PRODUCT CHANGE NOTICE

**PCN #** FFC2B15 B PCN  
20161220

FFC2B15-XX-X

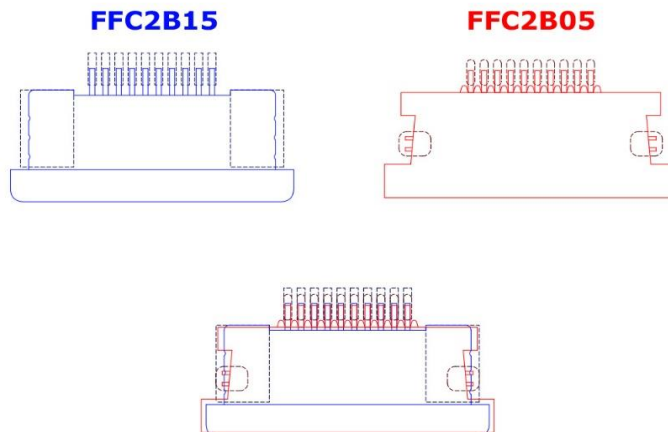
1. Made 'Not Suitable For New Designs'.
2. Remove Contact Numbers: 5, 7, 8, 9, 11, 13, 15, 16, 17, 18, 19, 21, 23, 24, 25, 28, 29, 31, 33, 34, 36, 37, 38, 39, 41, 45, 48, 50, 57 & 60.
3. Gold plating only available in 30 and 54 contacts.

Alternatives to achieve a given required number of contacts by using the FFC2B05.

Footprint comparison as follows (height differences FFC2B15 2.00mm vs FFC2B05 1.20mm):
